Installation of New ALPS Treated Water Dilution/Discharge Facilities and Related Facilities

March 1, 2022

Tokyo Electric Power Company Holdings, Inc.

Responses to issues pointed out* at the review meeting, etc.

Results of examining the stress intensity at areas for study

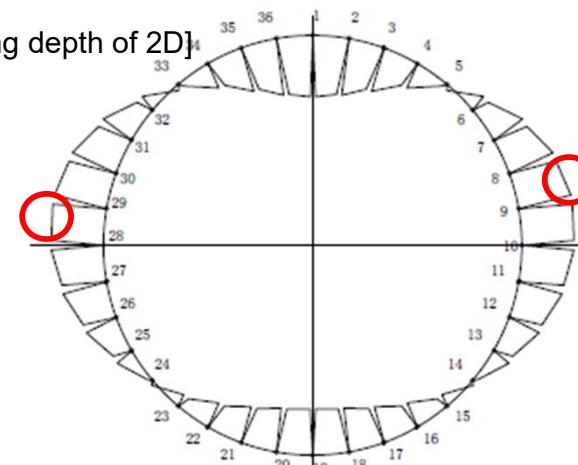
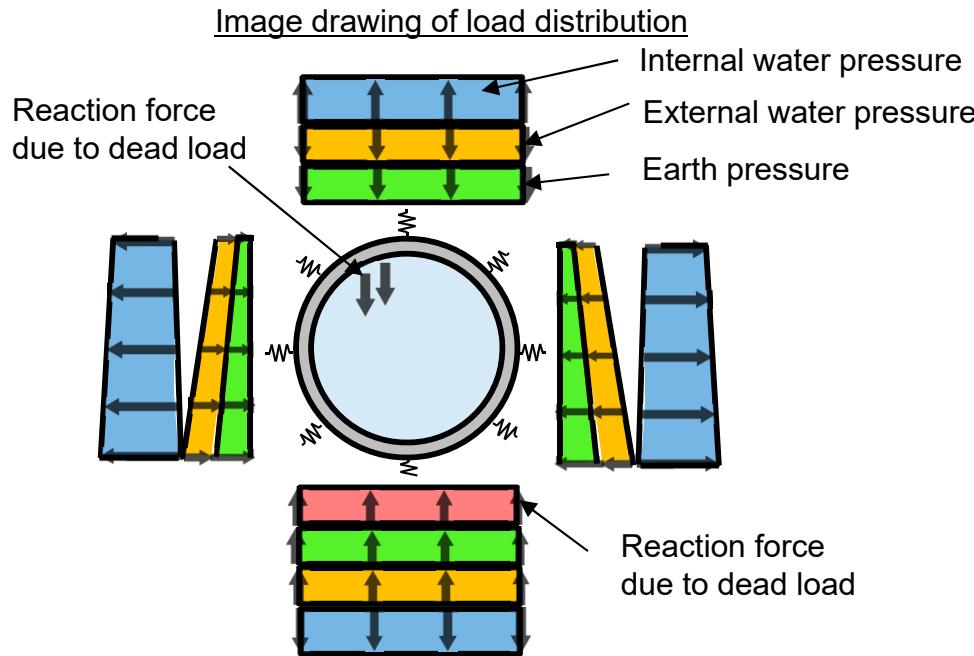
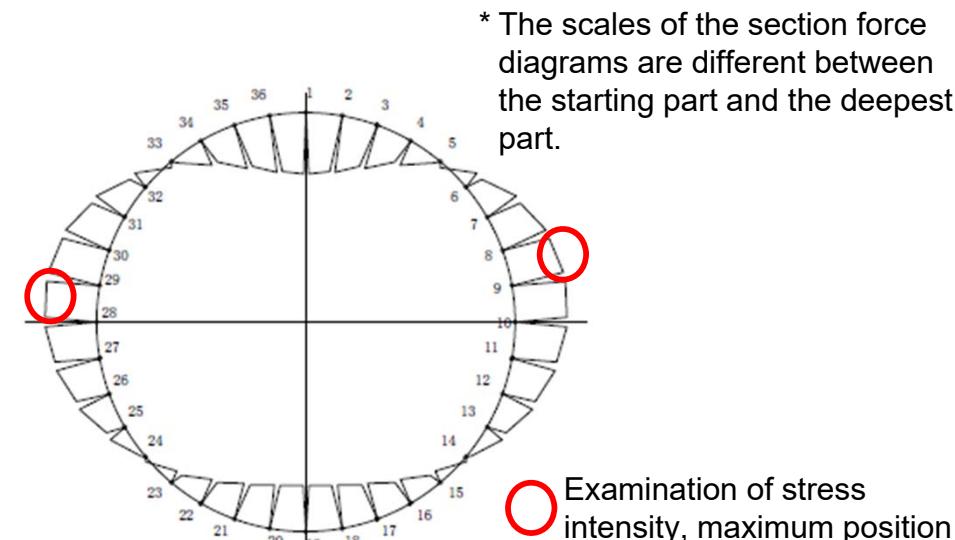
- Regarding Discharge Facility, allowable values for the displacement amount in the results of examining displacement at the time of earthquakes and the basis for setting the values should be organized and presented.
- As for the results of the stress intensity examination in the cross-sectional direction of the discharge tunnel, tolerance to stress increments due to ground displacement at the time of earthquakes should be organized and presented.

[In normal times, at full water (Short-term inside water level: T.P. + 9.3 m), earth covering depth of 2D]

Starting part: Section force diagram (bending moment)

Results of examining the stress intensity of the lining plate (segment)

Areas for study	Stress intensity examination (Operating/Allowance)	
	Bending moment	
Lining plate (starting part)	0.39	
Lining plate (deepest part)	0.46

Deepest part: Section force diagram (bending moment)

[Supplement] Section force diagram at the time of earthquakes

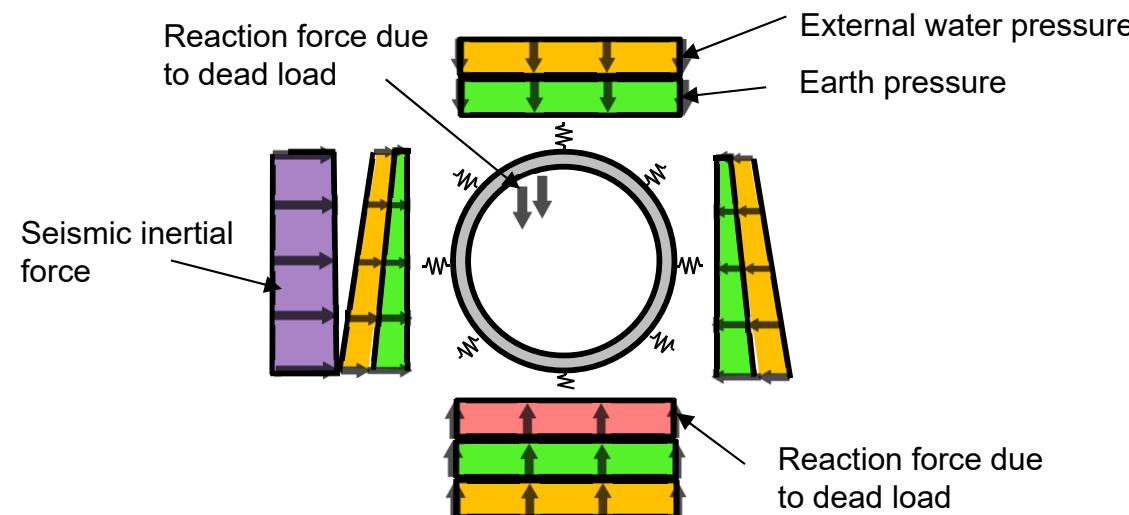
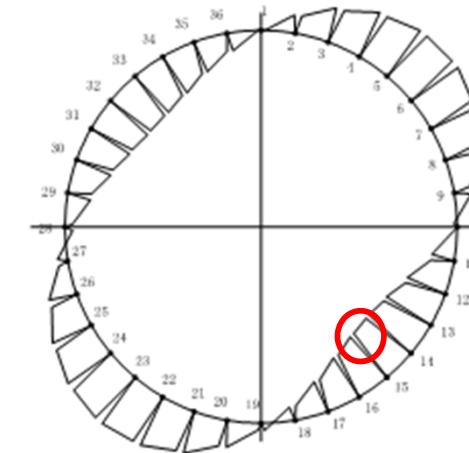
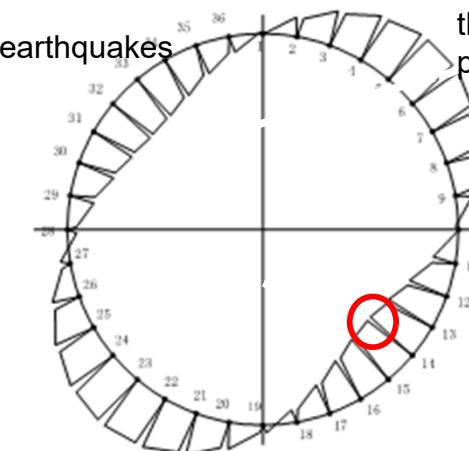
- As shown in the figure left, the discharge tunnel without water is the critical case at the time of earthquakes.
- When filled with full water, as shown in the right figure, the seismic inertial force acts in the opposite direction to the internal water pressure, reducing the horizontal force. Accordingly, it is not a critical case.

[In normal times + at the time of earthquakes, no water, and overburden depth of 2D]

Assuming there is no water during construction (there is only external water pressure).

Results of examining the stress intensity of the lining plate (segment) at the time of earthquakes

Areas for study	Stress intensity examination (Operating/Allowance)	
	Bending moment	Compression force
Lining plate (starting part)	0.15	0.27
Lining plate (deepest part)	0.15	0.29

Starting part: Section force diagram (bending moment)

○ Examination of stress intensity, maximum position
Deepest part: Section force diagram (bending moment)

[2]-1. Judgement criteria for mixing/dilution

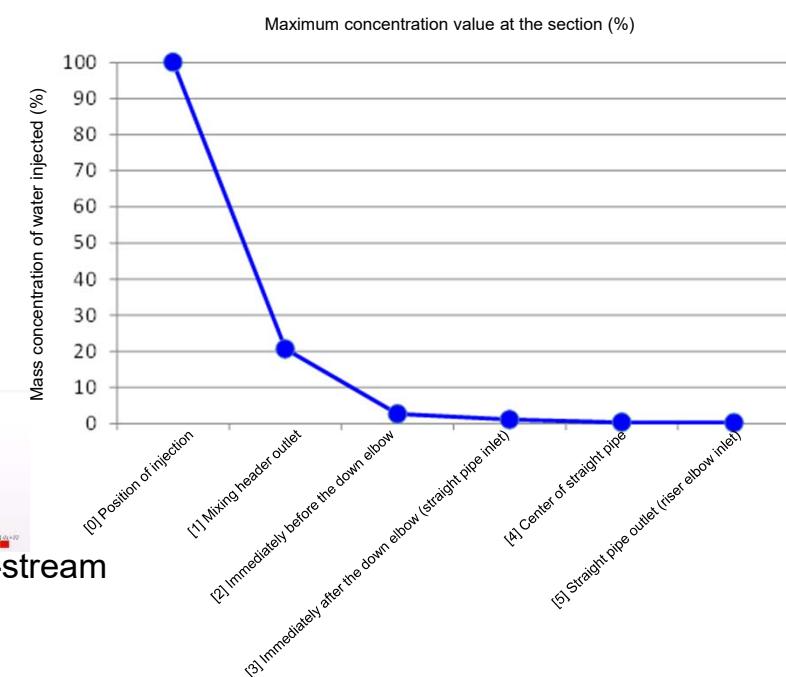
- In response to the results of simulating the mixing/dilution of ALPS treated water with seawater, rather than the Average concentration distribution in the seawater pipe header, the criteria for judging that the concentration is nearly below 1,500 Bq/L, as well as the position satisfying those criteria, including the concept, should be specified. When the above-mentioned is ensured with operation and procedures, how that can be incorporated into the design should also be indicated.

- Fluid analysis calculated the mass concentration of ALPS treated water injected at sections inside the seawater pipe.
 - In evaluating the seawater flow rate of 340,000 m³/day and ALPS treated water flow rate of 500 m³/day, the theoretical mass concentration was 0.14%.
- Based on the maximum mass concentration of ALPS treated water on the respective sections, the status under which mixing/dilution progress was evaluated.
 - [4] After the center of the straight pipe, the maximum mass concentration of the ALPS treated water was below 1%, and it was determined that the mixing/dilution had progressed on the whole.

Name	Maximum concentration value at the section (%)
[0] Position of injection	100
[1] Mixing header outlet	20.6
[2] Immediately before the down elbow	2.65
[3] Immediately after the down elbow (straight pipe inlet)	1.10
[4] Center of straight pipe	0.30
[5] Straight pipe outlet (riser elbow inlet)	0.23

[2] -2. Change in the pipe shape accompanied by the determination of discharge vertical shaft structure

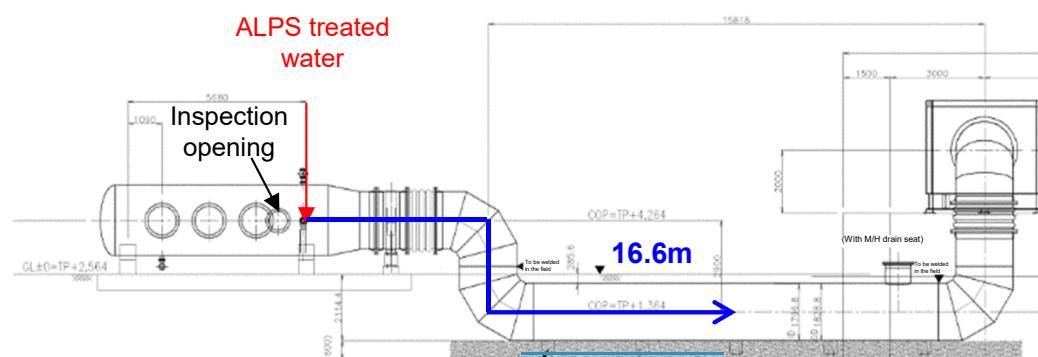
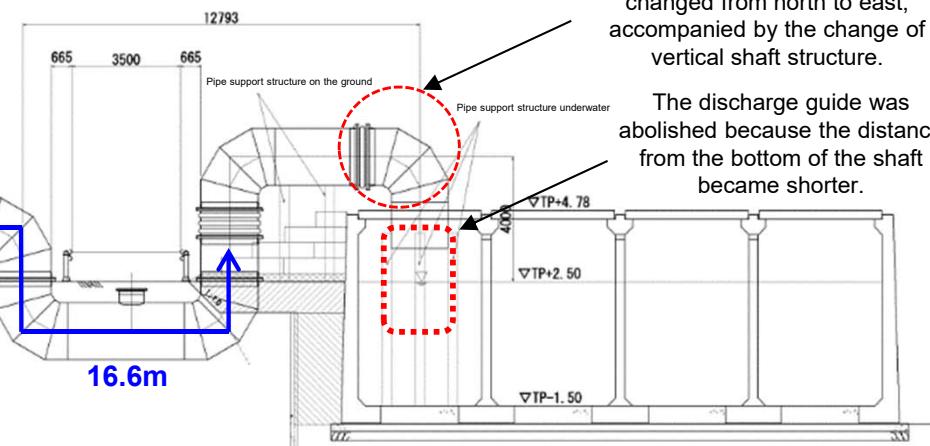
- The effect caused by the determination of the discharge vertical shaft structure on the other facilities, including seawater pipe headers, should be explained.

- The design of the seawater pipe has changed associated with the determination of the discharge vertical shaft structure.
 - In modifying the design, without changing the pipe diameter, the pipe length, which is longer than the (4) of the center of straight pipe, was secured with the maximum mass concentration of ALPS treated water below 1% in the previous analysis.
 - Fluid analysis based on the changed shape has been conducted to verify the effect of mixing/dilution.
 - ✓ In performing the reanalysis, the maximum mass concentration will be assessed by modeling the seawater pipe header through the end of the pipe.

The discharge end has been changed from north to east, accompanied by the change of vertical shaft structure.

The discharge guide was abolished because the distance from the bottom of the shaft became shorter.

Changing the pipe spacing by optimization of the check valve arrangement

Pipe size (Header pipe: 2200 A, downstream pipe: 1800 A) unchanged

[Supplement] Interlocks that do not exceed the target discharge management value

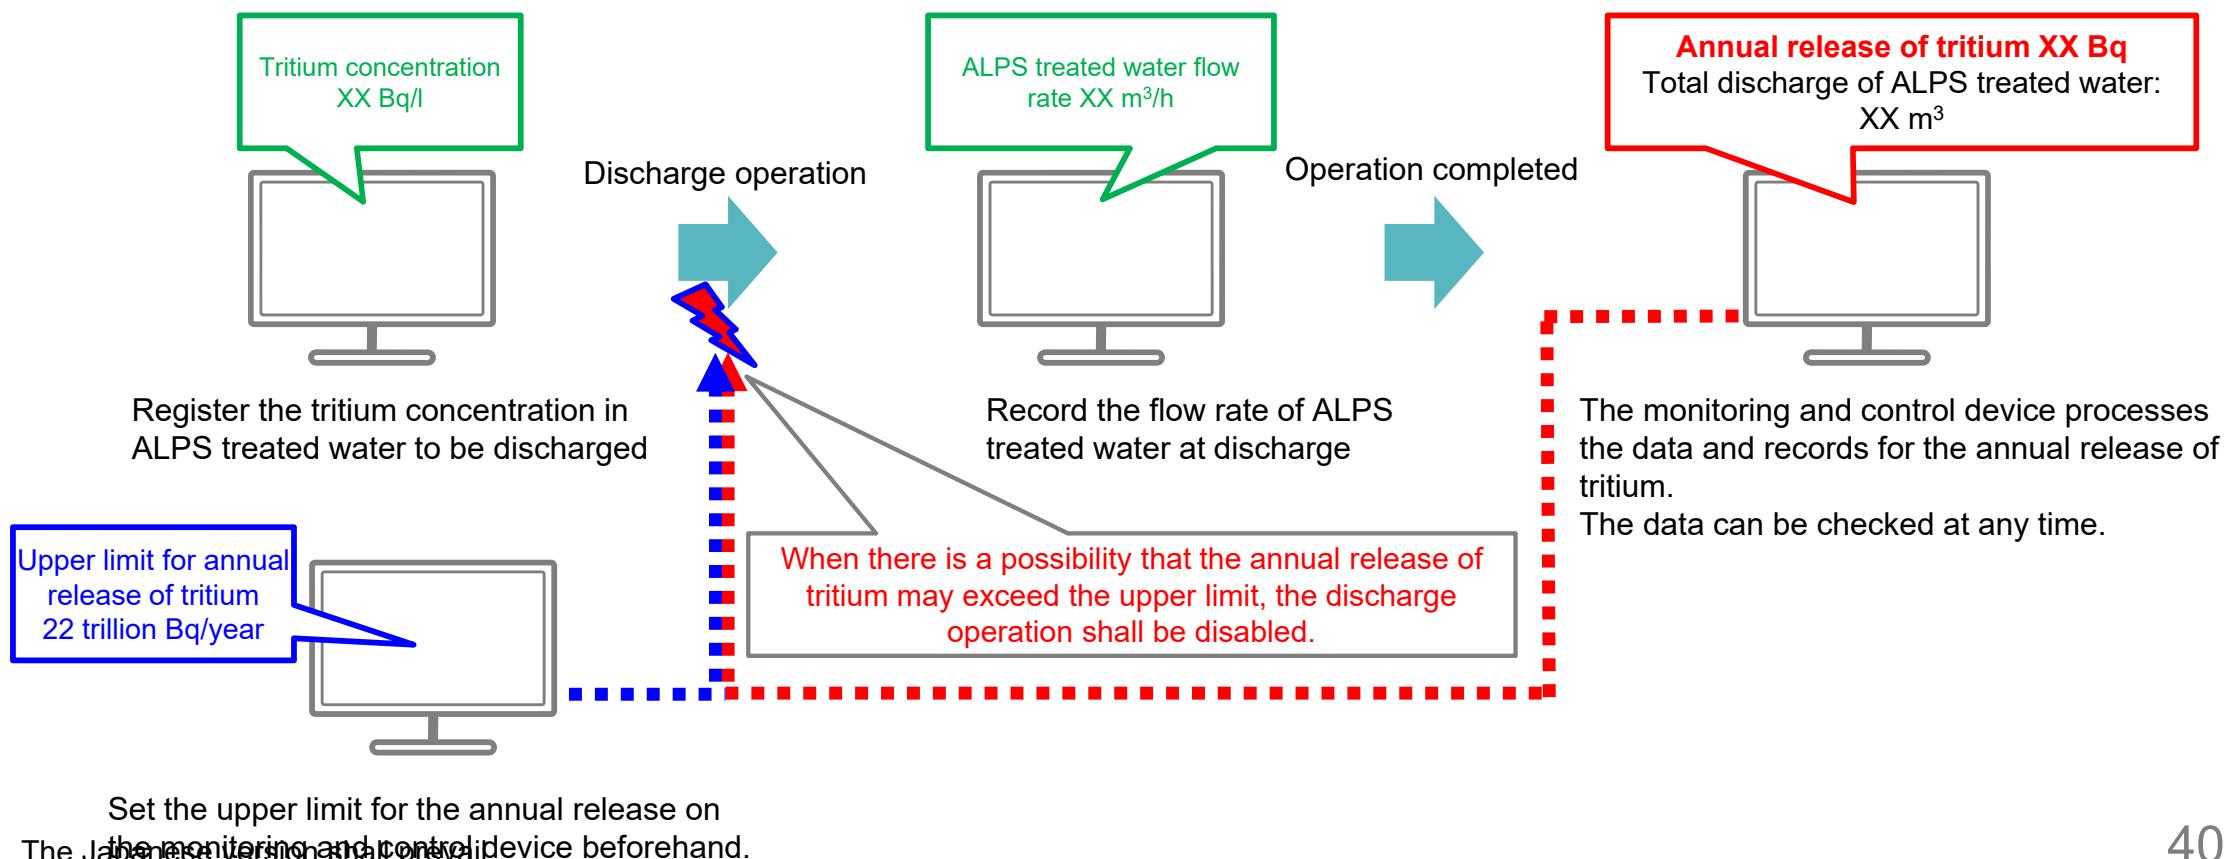
- In controlling the annual release of tritium, other than stopping discharge operation mechanically through interlocks, an explanation should be given on the basic contents of the annual discharge plan that TEPCO verbally explained this time, and the discharge control methods based on the plan.

- In the ALPS treated water dilution/Discharge Facility, the tritium concentration in ALPS treated water to be discharged is registered to the monitoring and control device each time before discharge, and the monitoring and control device monitors the flow rate of ALPS treated water at discharge, counting and recording the total flow rate.

- As for annual tritium discharge, the monitoring and control device sums up the results obtained by multiplying the tritium concentration registered each time of discharge and the integrated flow rate, and the data can be checked at any time.

- This device can also set the upper limit of the annual release of tritium, and is equipped with an interlock system that does not allow the system to shift to the discharge operation when there is a possibility of exceeding the limit. In this way, the system is controlled so as not to exceed the target discharge management value for discharge per year (22 trillion Bq).
